Chapter 7 – Responses to Comments

The Draft EIR for the proposed Metro Gold Line Foothill Extension – Azusa to Montclair was made available for a 45-day public review and comment period pursuant to the State CEQA Guidelines, Sections 15105 and 15087, beginning on August 5, 2012 and ending on October 5, 2012. The Metro Gold Line Foothill Extension Construction Authority also held public meetings to receive comments on the Draft EIR on September 20, 2012, at 5:30 p.m. in Montclair, and on September 24, 2012 at 5:30 p.m. in La Verne.

EXHIBIT B
CITY OF POMONA RESIDENTIAL NEIGHBORHOOD LOCATIONS
ALONG METRO GOLD LINE PHASE II

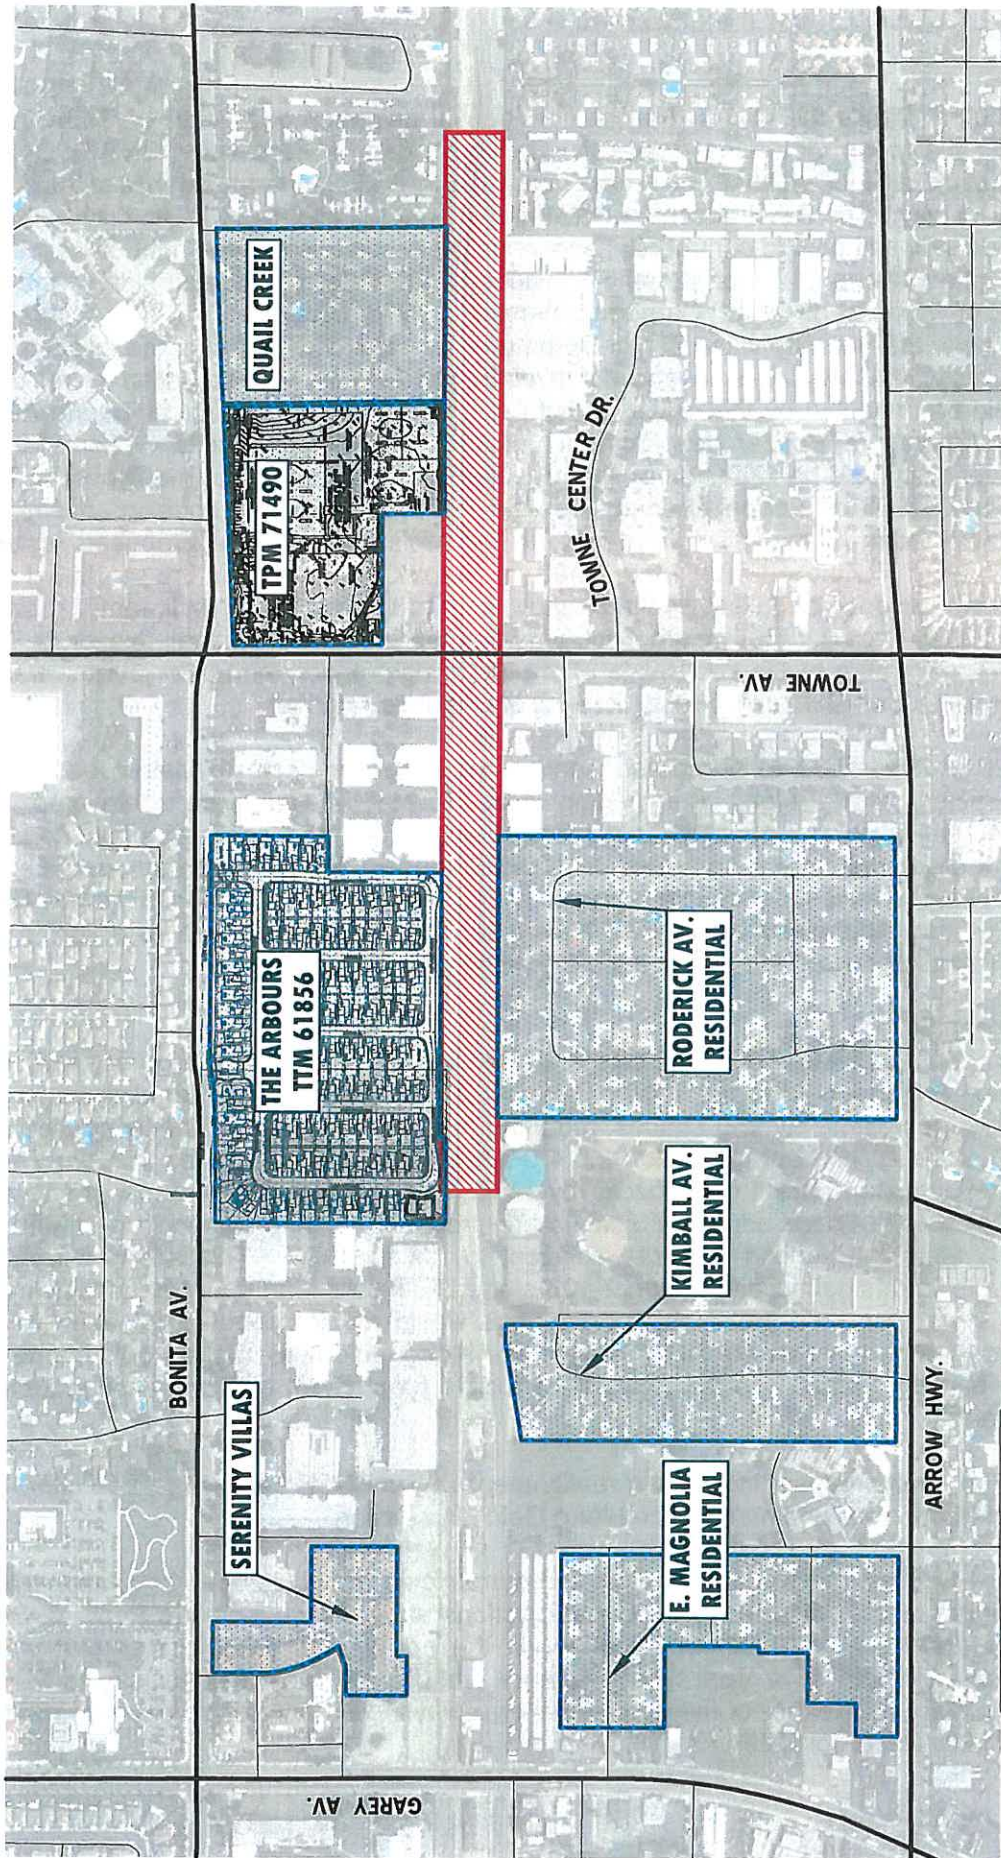
The DEIR describes the 1.4-mile light rail alignment in the City of Pomona as “entirely adjacent to commercial and industrial areas or Metrolink right-of-way with the exception of one 500 foot stretch of residential area along the north side of the Metro right-of-way just west of Carnegie Avenue.” This description is not accurate, for example, the Serenity Villas Senior Community is located just north of the existing freight line, east of Garey Avenue and south of Bonita Avenue:

POMONA STATION ACCESS CONSIDERATIONS METRO GOLD LINE PHASE II

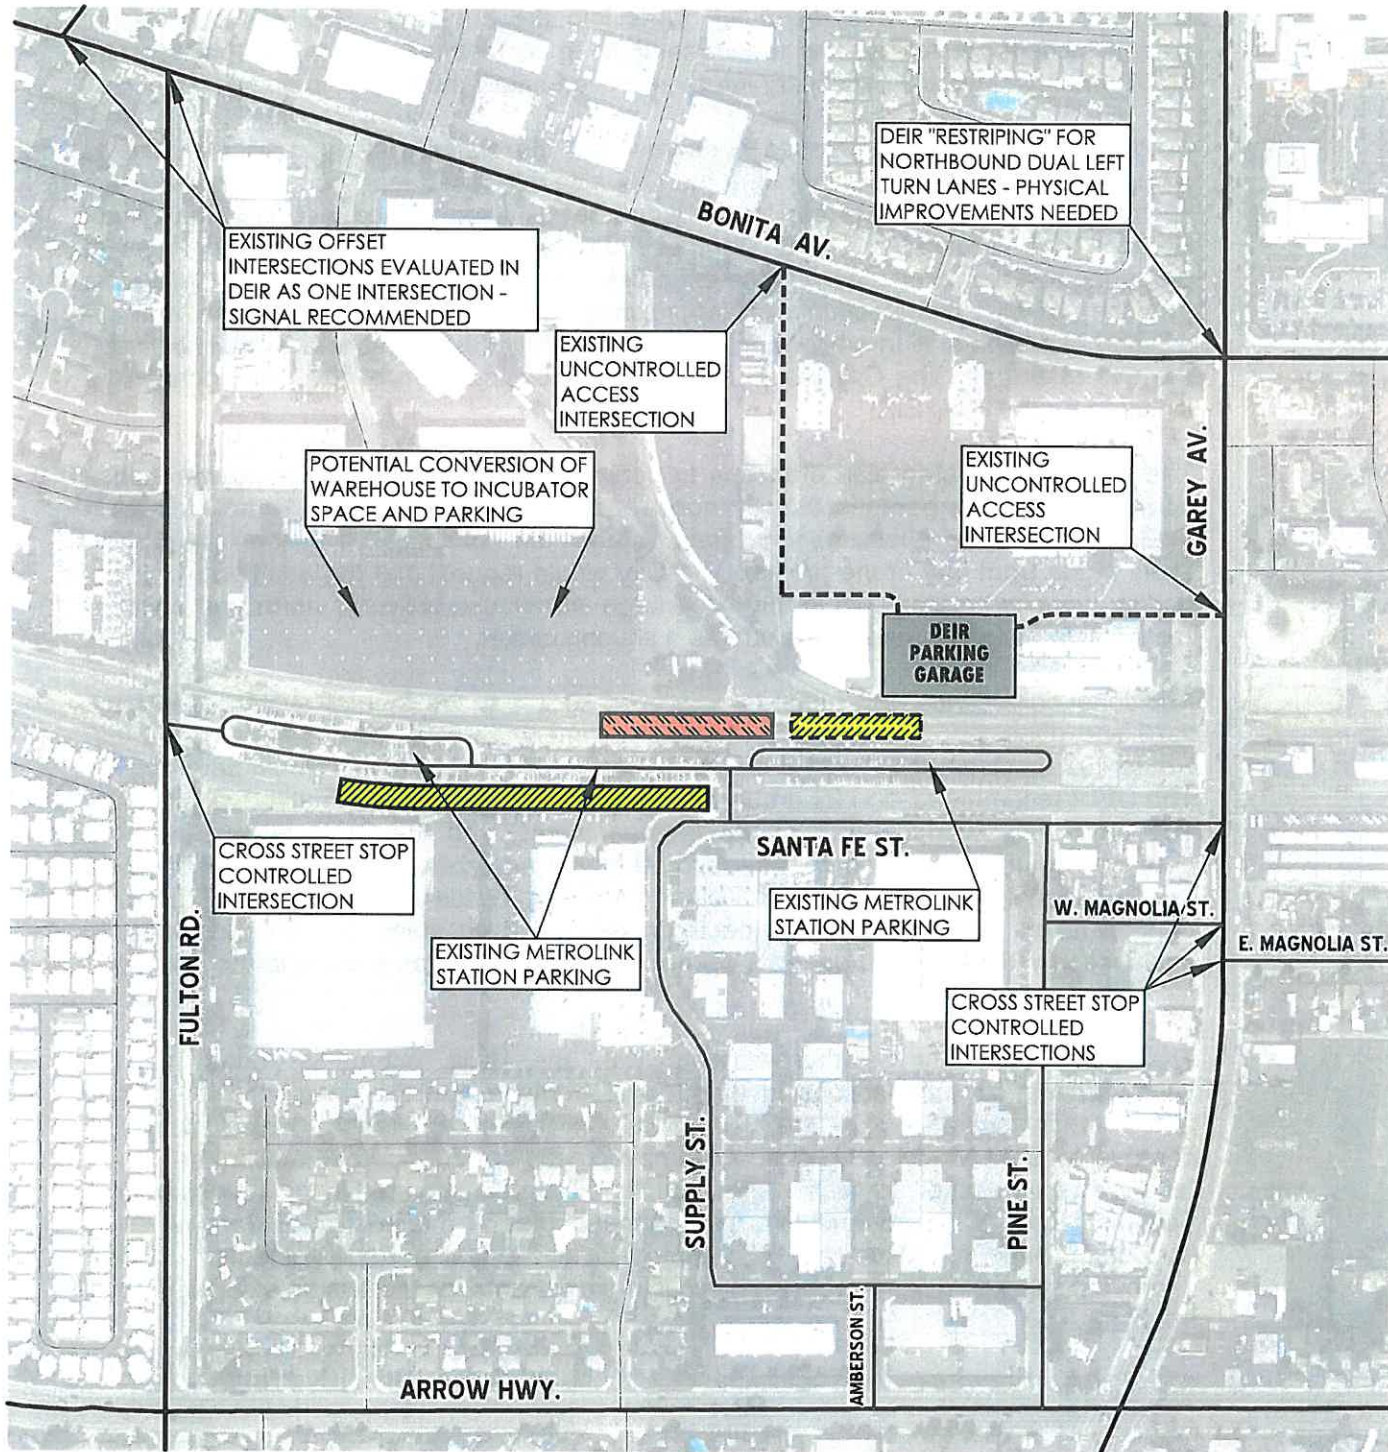
At the assumed driveway to Bonita Avenue, there is an existing striped median lane, which accommodates westbound left turns into the driveway. Analysis of potential station access driveways is recommended to determine appropriate intersection configurations, and any necessary future improvements if the project is approved.

In 2011, the City had expressed concerns with the platform location as it relates to pedestrian accessibility. At that time the City also requested that the access and rights to the property for the north parking structure be identified. Since that time, the City of Pomona has received a SCAG Compass Blueprint grant and is in the process of preparing a station area plan with the expertise of a TOD design firm (Cooper Carry) that proposes to shift this location west approximately 300-400 feet to be in line with the existing Metrolink station platform to create a better pedestrian access system between the two platforms. The City would request that consideration of this new location be included for the Final EIR.

Figure 4. AM Peak Hour Northbound and Southbound Queues

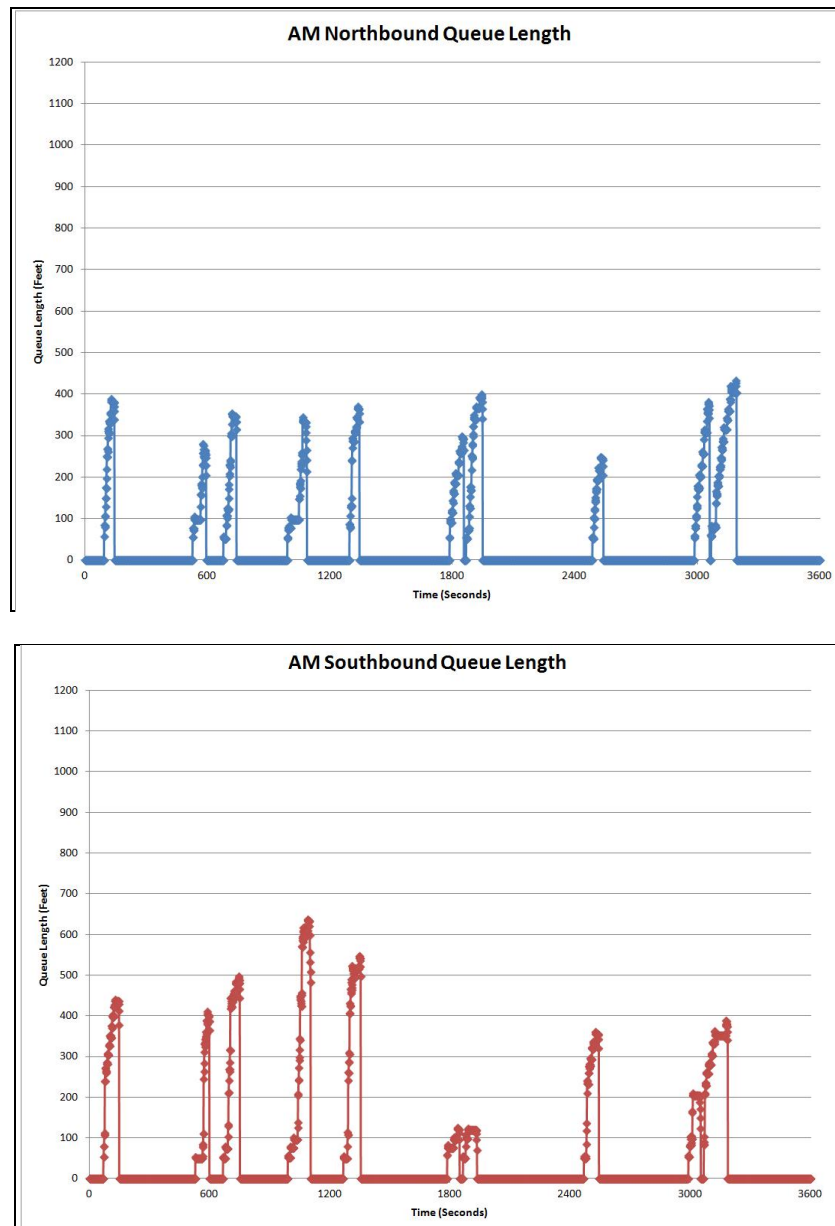
For the Year 2035 Build scenario during the AM peak hour, the Northbound queue at the train gate was approximately 433 feet (17 vehicles) and the Southbound queue was approximately 637 feet (25 vehicles), as shown in Figure 4.

Figure 5. PM Peak Hour Northbound and Southbound Queues

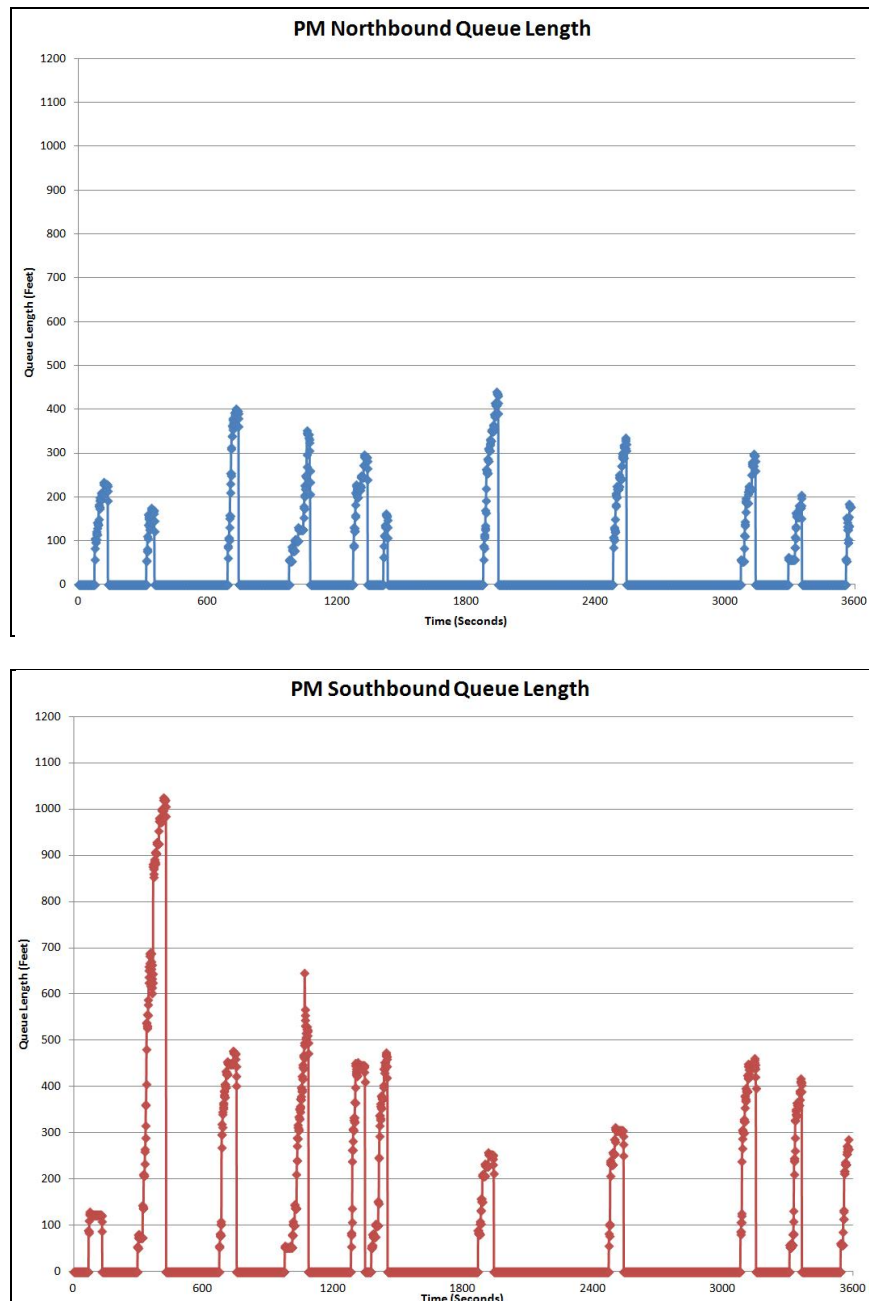
For the Year 2035 Build scenario during the PM peak hour, the Northbound queue at the train gate was approximately 441 feet (18 vehicles) and the Southbound queue was approximately 1025 feet (41 vehicles), as shown in Figure 5.

As shown in Figure 5, the greatest queues are observed in the PM peak hour with the maximum Northbound queue length of approximately 441 feet (18 vehicles) and the maximum Southbound

EXHIBIT A

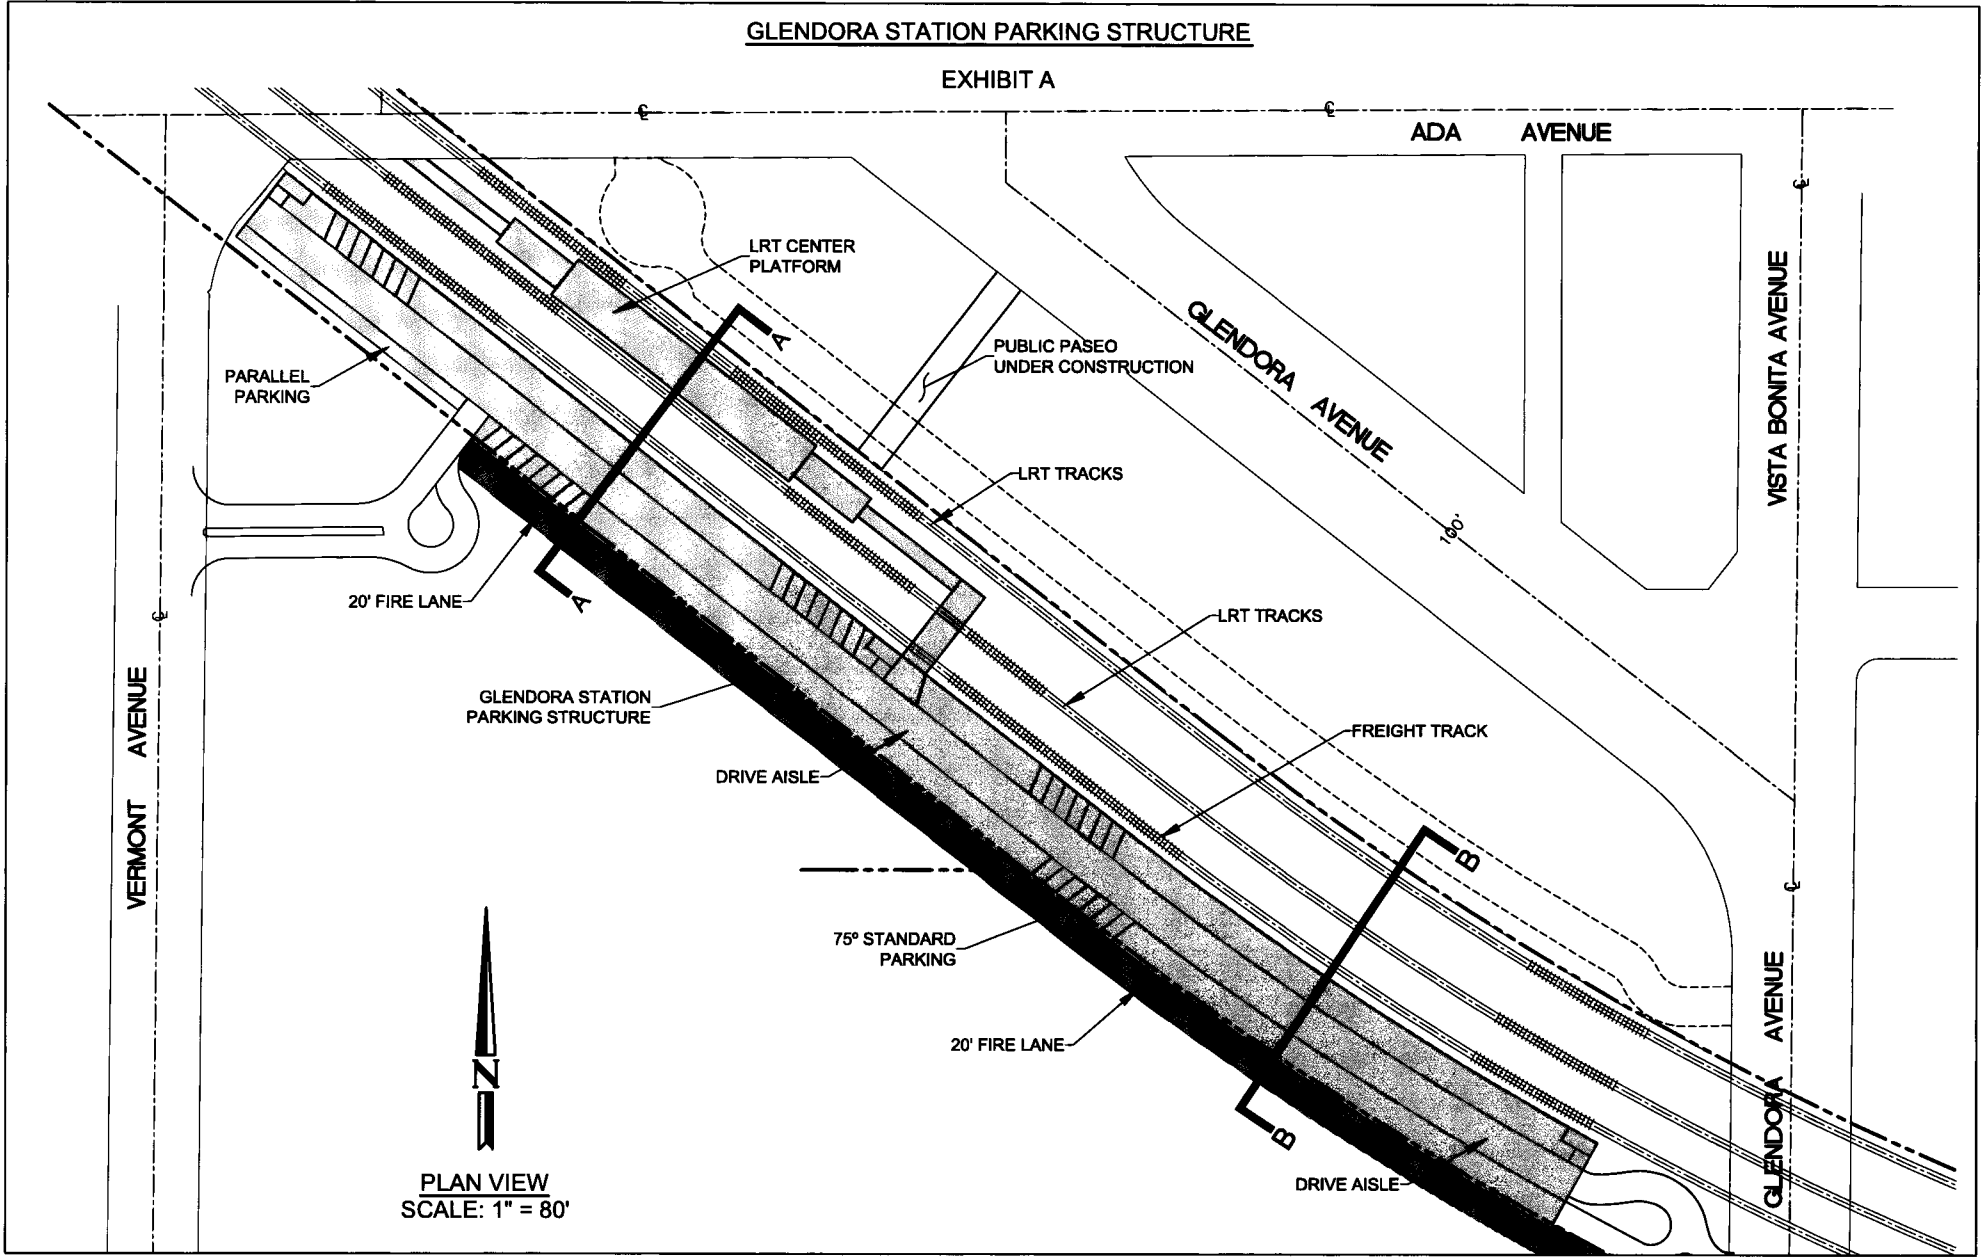
Page 3.5-1 This page has a paragraph indicating that the California Building Code and Uniform Fire Code must be complied with during this project. As previous stated as well as shown in Exhibits A B & C, when following these codes, there is not enough space available to construct the parking structure in Glendora as depicted in Figure 1-11. 26-14

The physical layout of the parking structure at Glendora Station is depicted in Figure 1-11 of the Draft EIR. Track spacing is depicted in Appendix A of the Draft EIR.

Nonetheless, the Construction Authority, in response to the issues raised by the City of Glendora, has considered a redesigned parking structure that is similar in design and location as shown in Exhibit 2B of the comment letter. This redesigned structure has been included in the Final EIR as “Option 2.”

FIGURE 2: Glendora Station with Center Platform
 PARKING GARAGE STUDY
 Land Exchange - Parking Garage / RV Parking
 Two-Way 90° Parking
 ± 420 Spaces

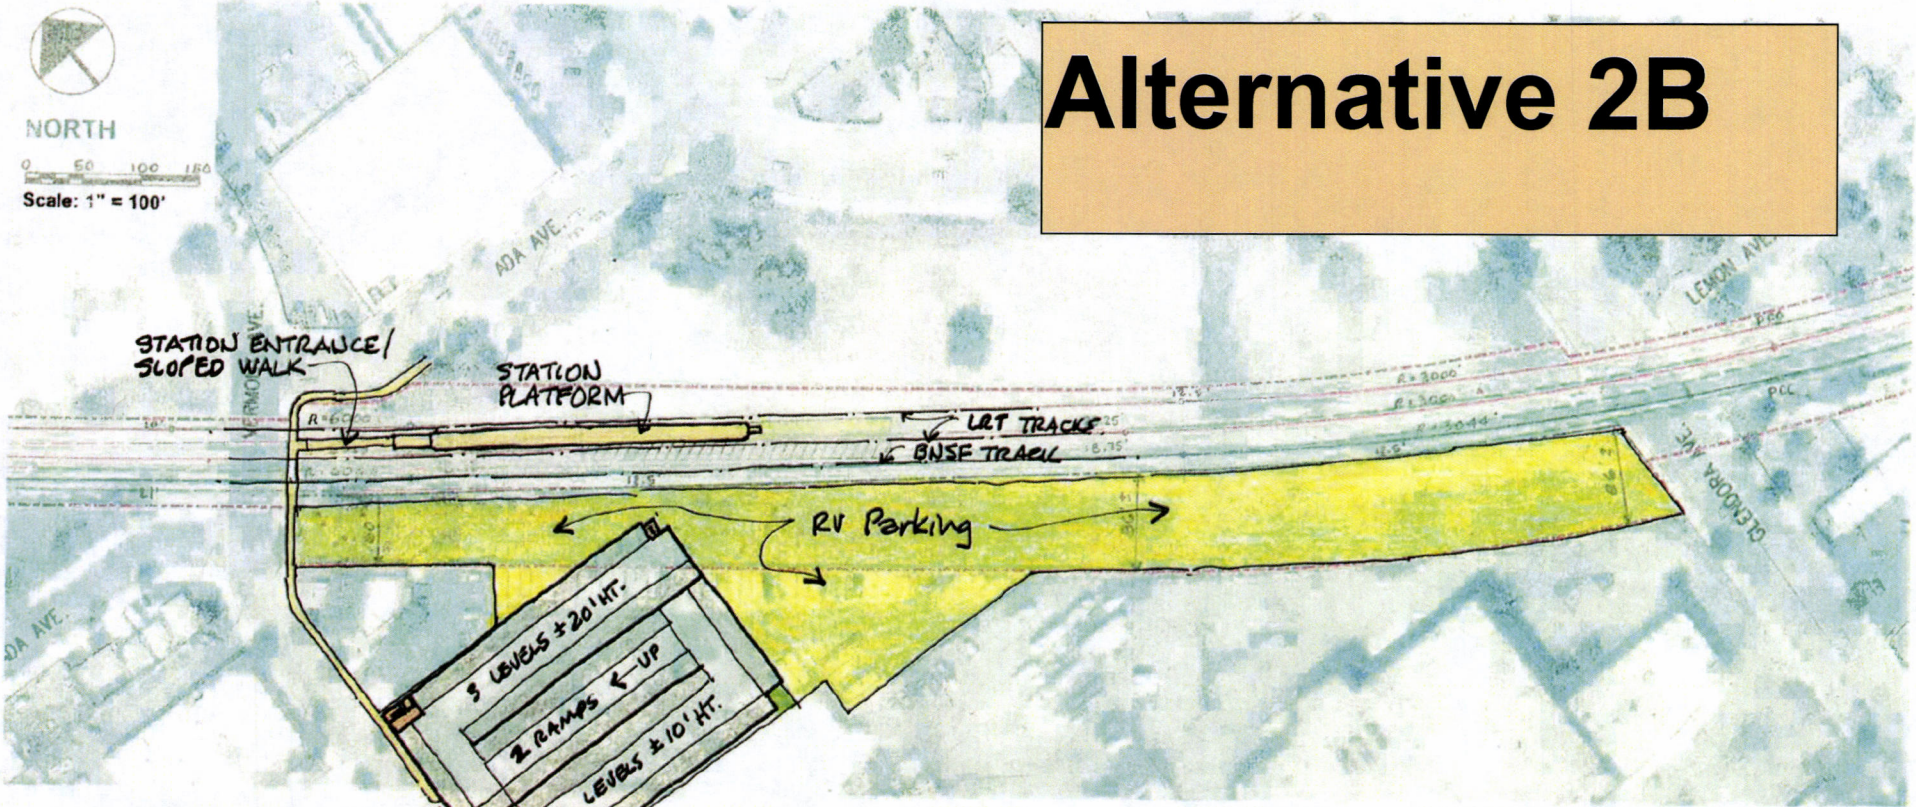
- Maximizes parking capacity
- Restricts BNSF/LRT track separation to 75' at platform area
- Minimizes Glendora Avenue street reconstruction
- Minimizes Vermont Avenue street reconstruction
- Will not impact existing leases/encroachments southeast of Glendora Avenue
- Minimal impact to residential encroachments northeast of Glendora Avenue
- Does not require an additional station platform
- NOTE: In both Figure 1 and Figure 2 the WB LRT and BNSF tracks are in identical positions
